FERMI 2
UFSAR CHANGE REQUESTS
UFSAR VOLUME XI

The following UFCNs and LCRs are approved for distribution but have not yet been incorporated in the UFSAR:

LICENSING CHANGE REQUEST

FIGURE 7.5-5

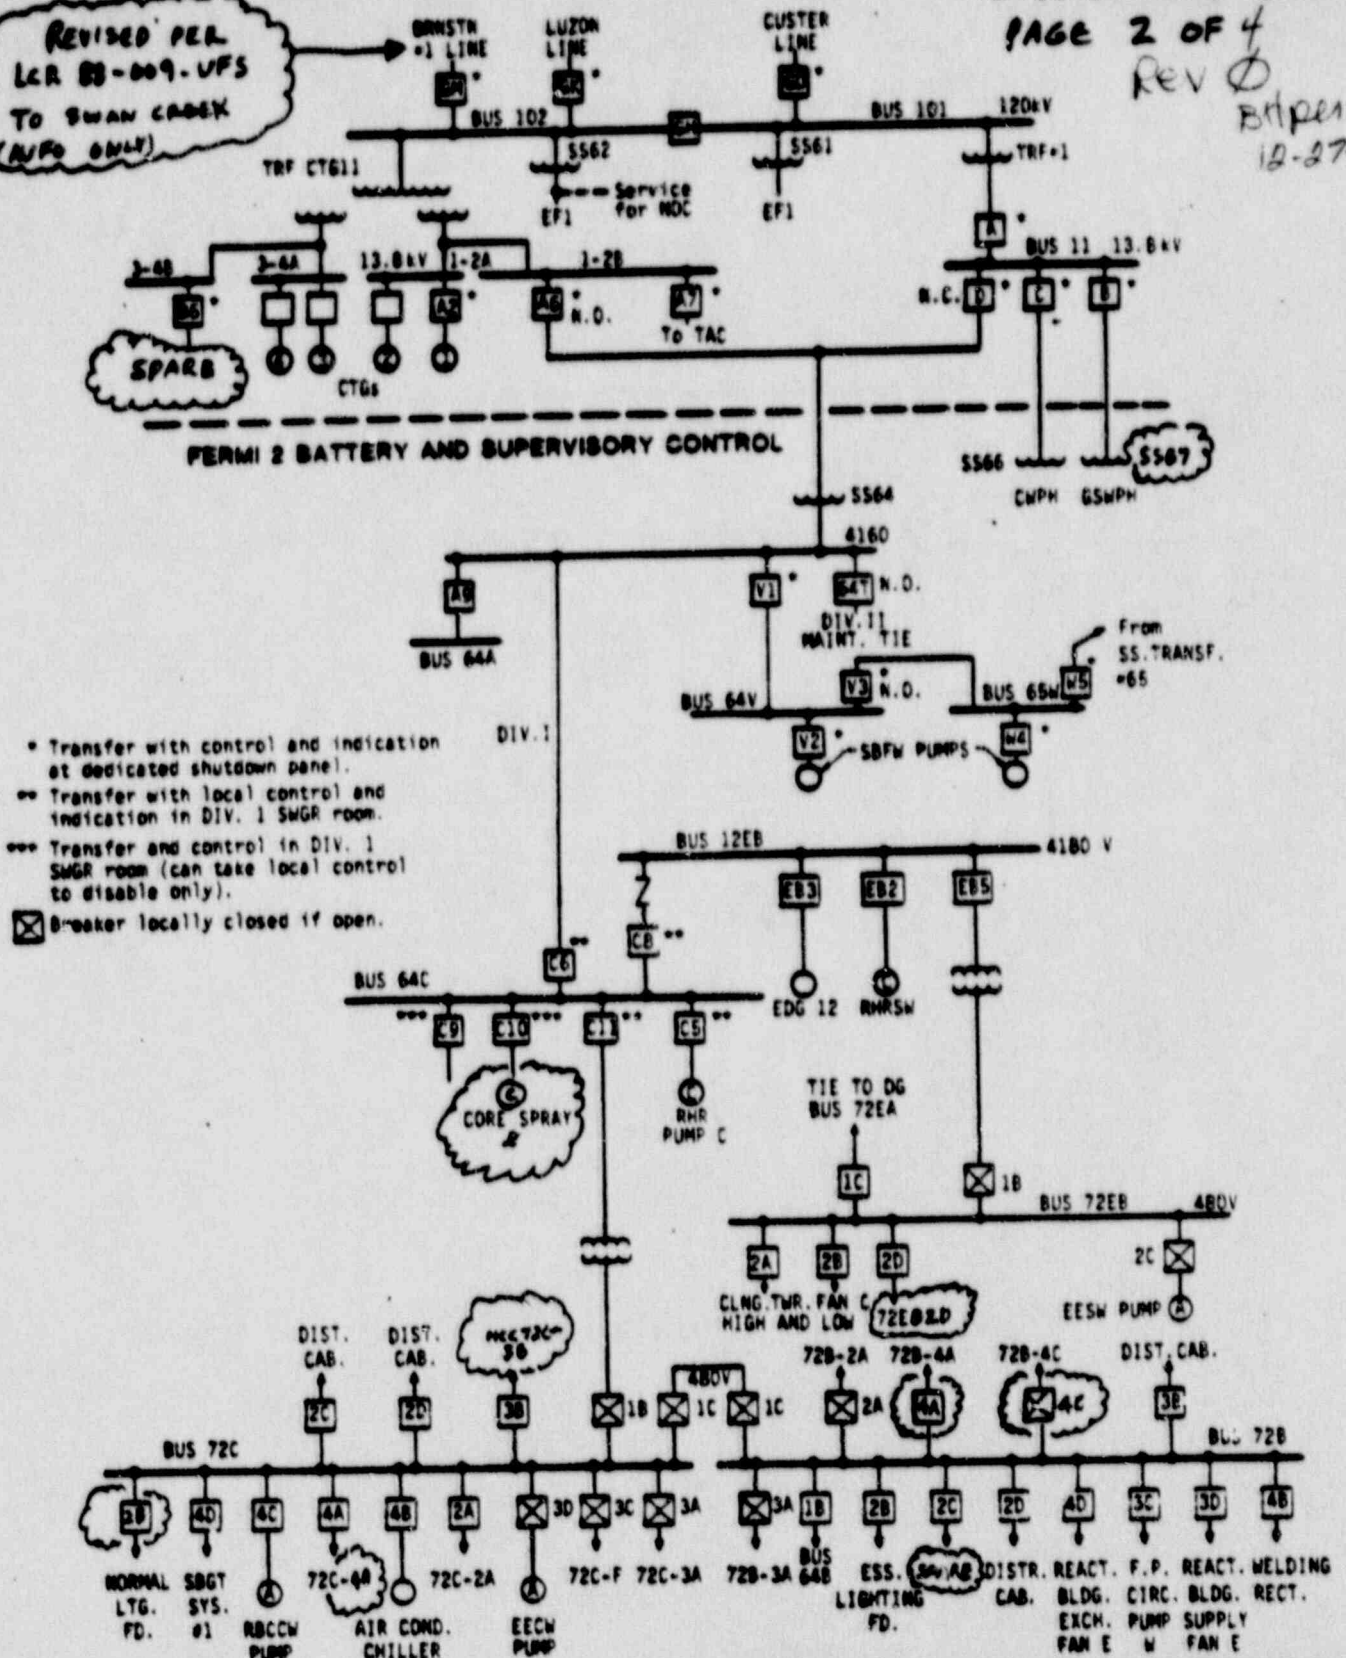
B) Section(s), Table(s), Figure(s), etc. Affected (Attach marked-up pages)
UFSAR Figure 7.5-5 - Attached

C) Reason for Change Editorial update of Figure 7.5-5 to agree with UFSAR Figures 8.3-1, 8.3-2, 8.3-5, 8.3-6 and NPP 20.000.18

Form 2 UPDATED FINAL SAFETY ANALYSIS REPORT	FIGURE 45-14, SHEET 2 CONTROL ROD DRIVE HYDRAULIC SYSTEM REACTOR BUILDING
---	---

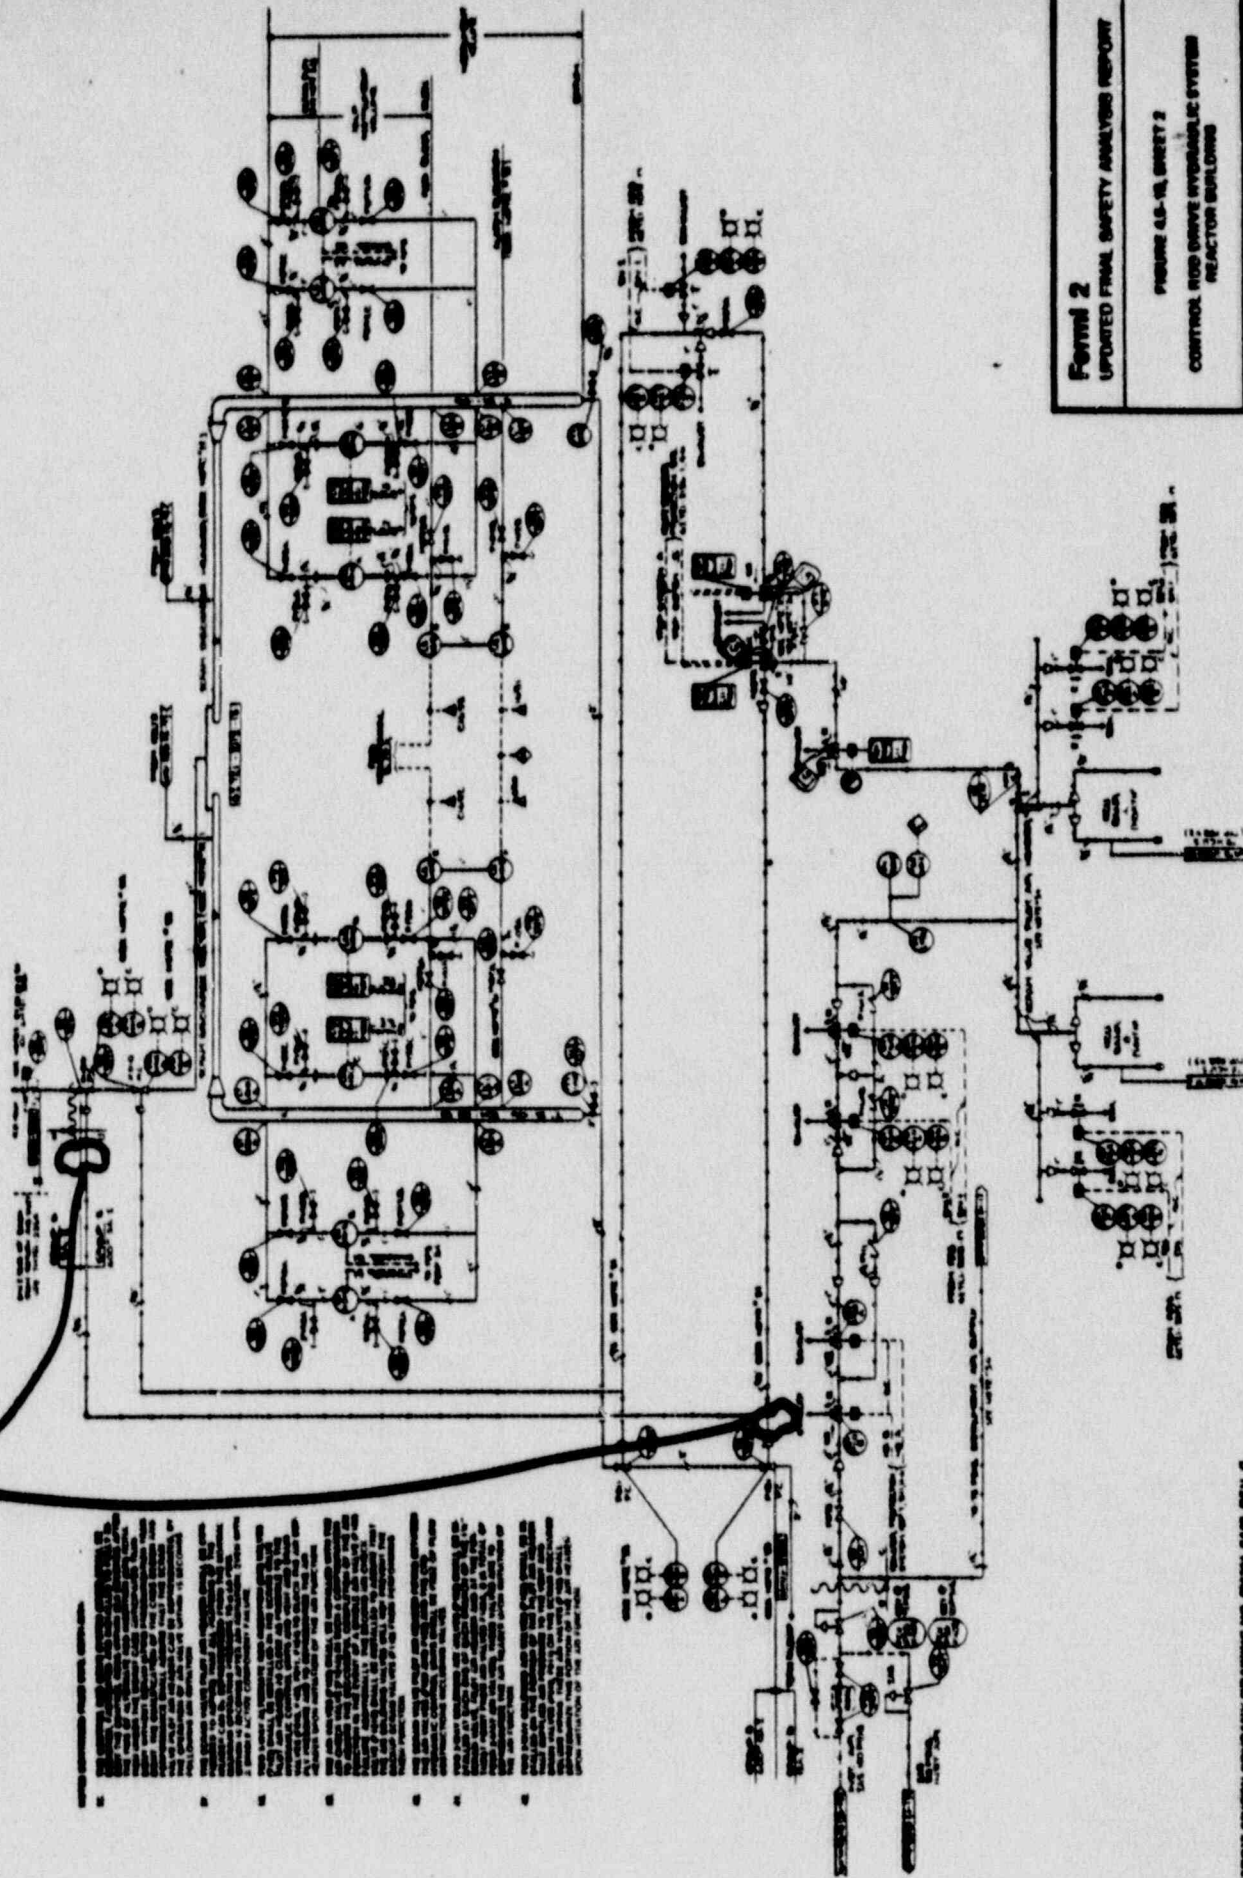
UFSAR Fig. 4.5-15 Sht. 2

C) Reason for Change Installation of check valve around air regulator for control air line to valve C1100F181.

LCR 89-242 - UFS
REV. 0
REVISE PER EDP 10962
SEE PAGE 3 FOR DETAILS
PAGE 2 OF 3

6M721-2023 (UFSAR FIG 10.4-10)
 ZONE D-5

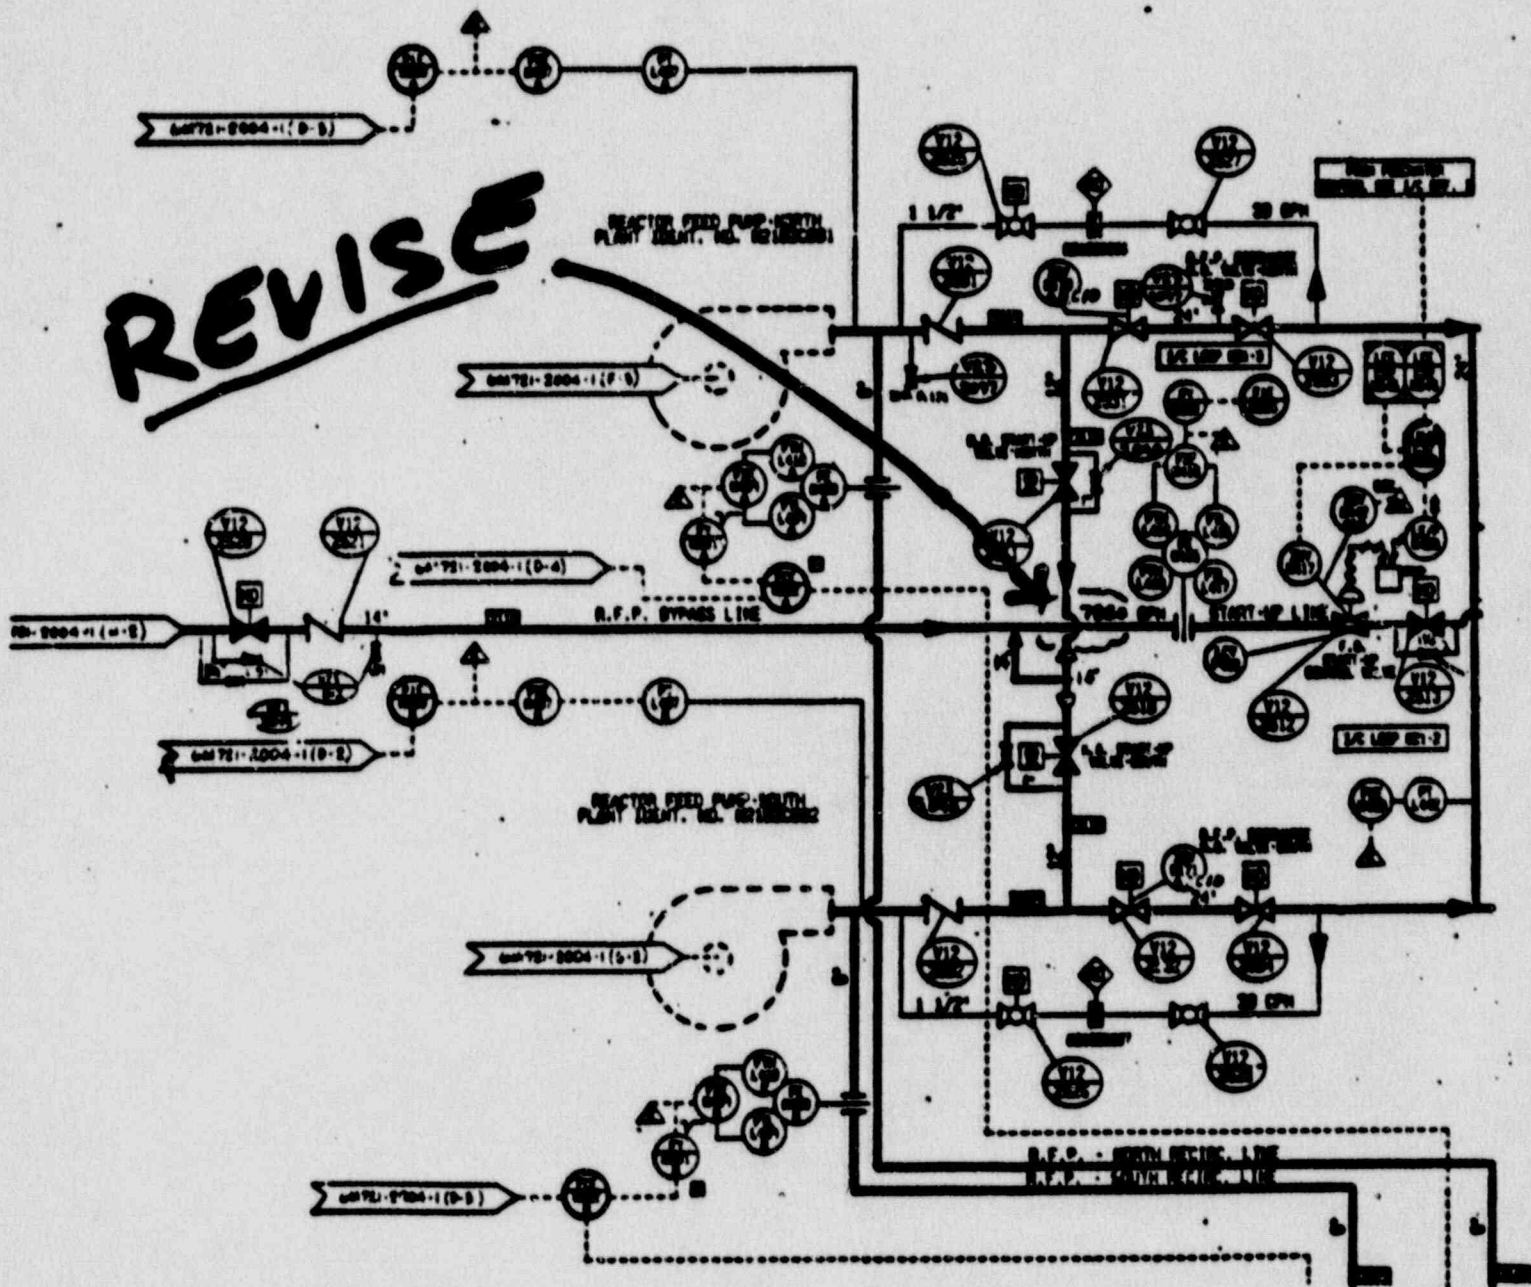
FIG 10.4-10 6701-2023

C) Reason for Change EDP 9952 INCREASES THE FW STARTUP LINE MAXIMUM FLOW FROM 6000 GPM TO 7000 GPM. THIS ALLOWS FOR MORE STABLE OPERATION WHILE TRANSFERRING TO RPT SPEED CONTROL

Section/Page	Change	Basis
FIG 10.4-10	SU LINE FLOW FROM 6000 GPM TO 7860 GPM	EDP 9952
BASIS FOR PART 1 A :	THE CHANGE INVOLVES ONLY QAZ EQUIPMENT AND THERE ARE NO PREVIOUS COMMITMENTS TO THE NRC.	
BASIS FOR PART 1 B :	THE CHANGE INVOLVE RESCALING A PROCESS TRANSMITTER. NO IMPACT TO FIRE PROTECTION

DIAGRAM-OFF GAS PROCESS SYSTEM

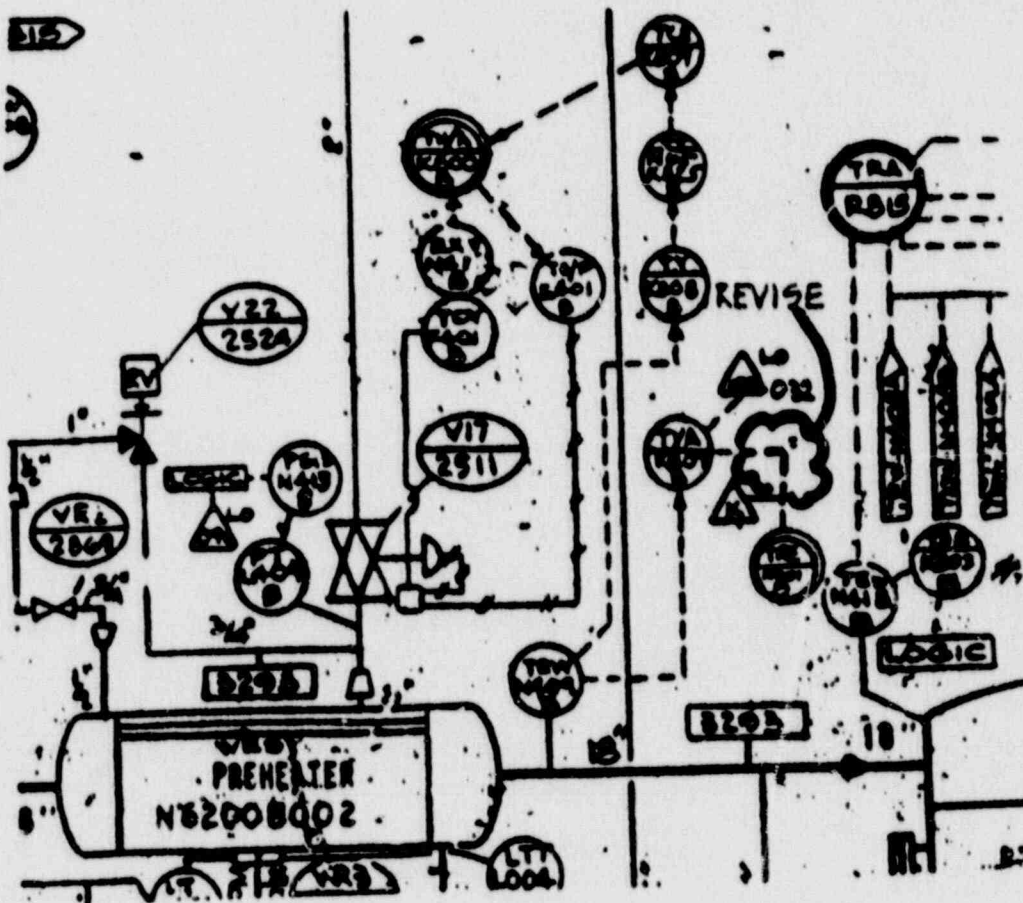
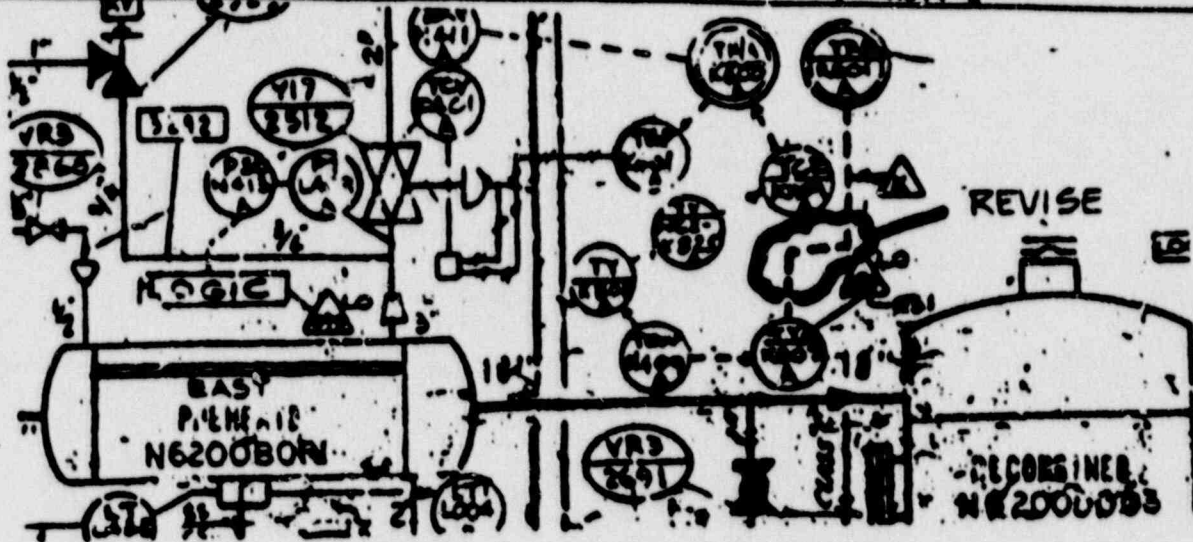
Figure 11.3-1, sheet 1

Elimination of auto-isolators N62K820A and B due to replacement of Offgas Preheater

Temperature recorders N62R801A and B.

Correction of drawing reference.

LCR 89-073. UFS REV. 0
UFSAR FIGURE 9.5-4
Pg 2 of 4

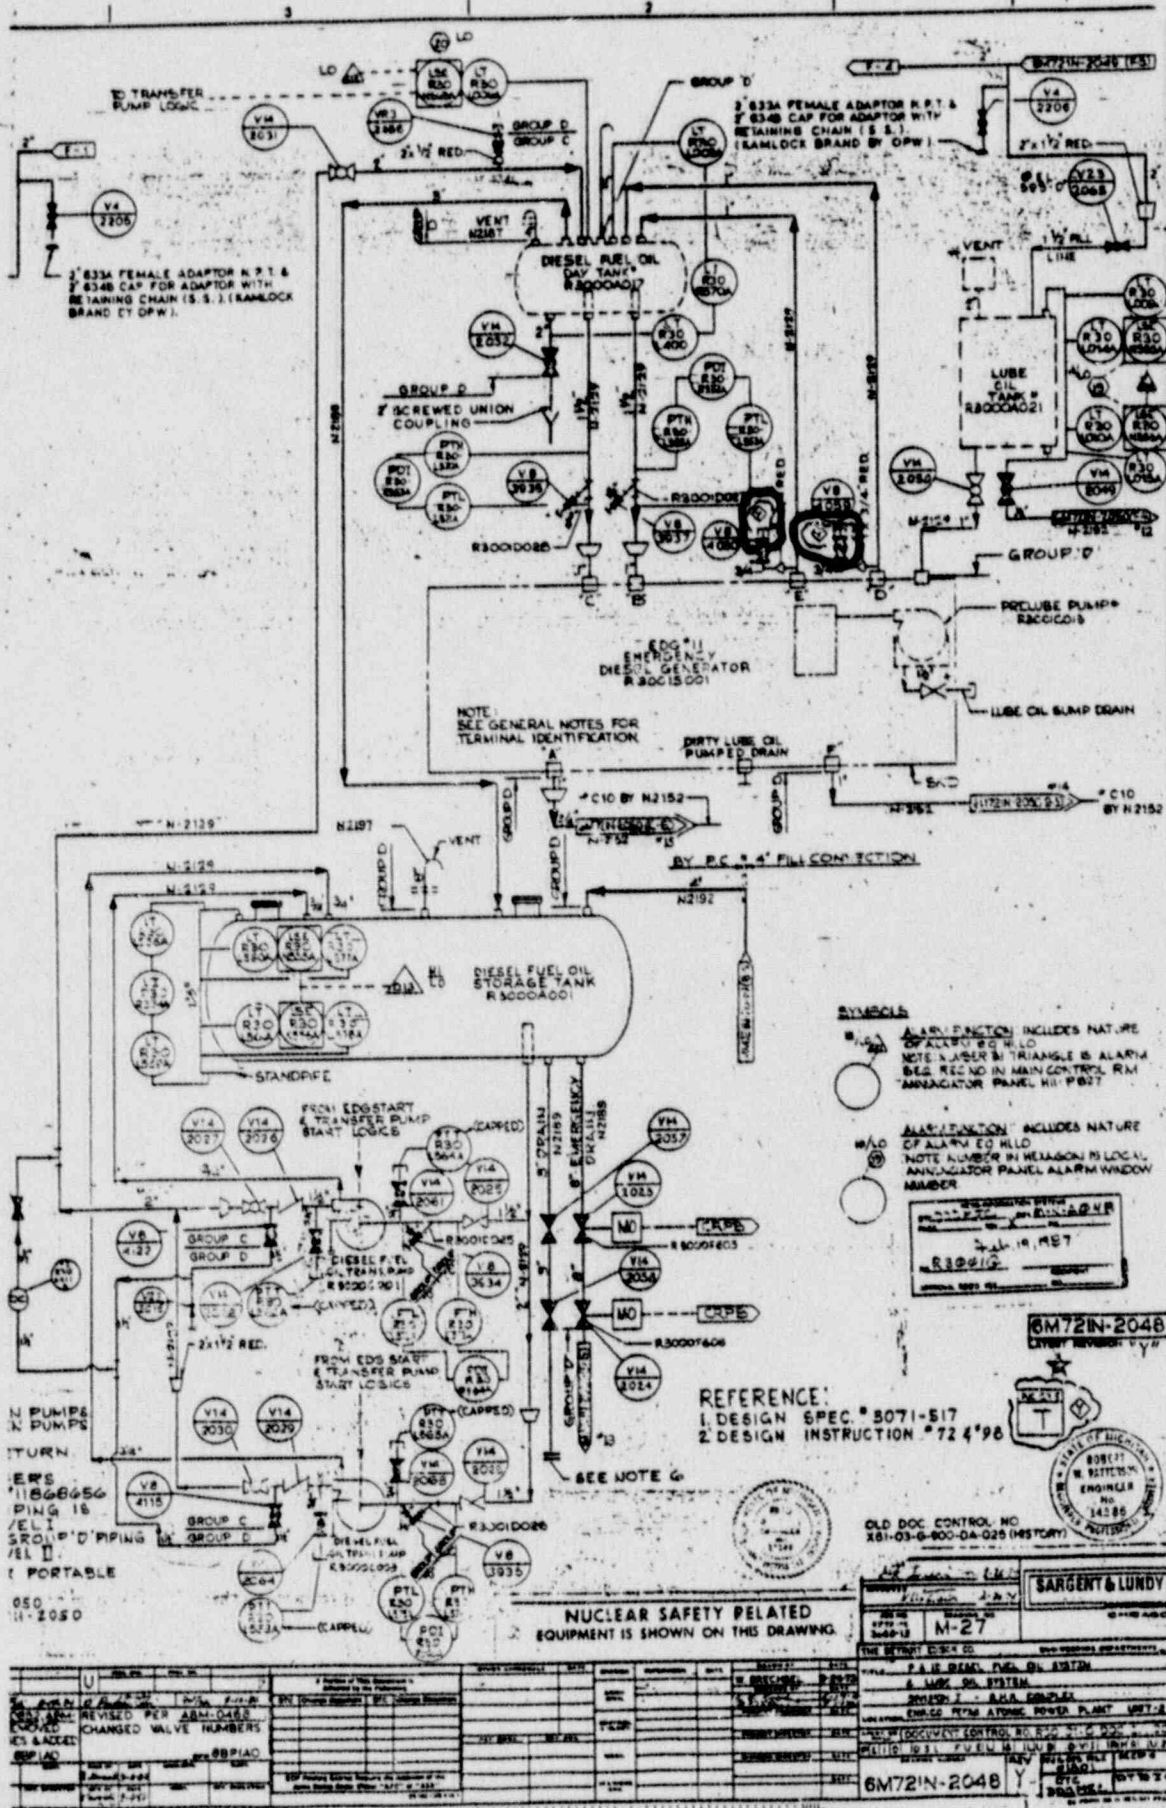
FIGURES 9.5-4, 9.5-5, 9.2-6

C) Reason for Change LOCKED VALVES
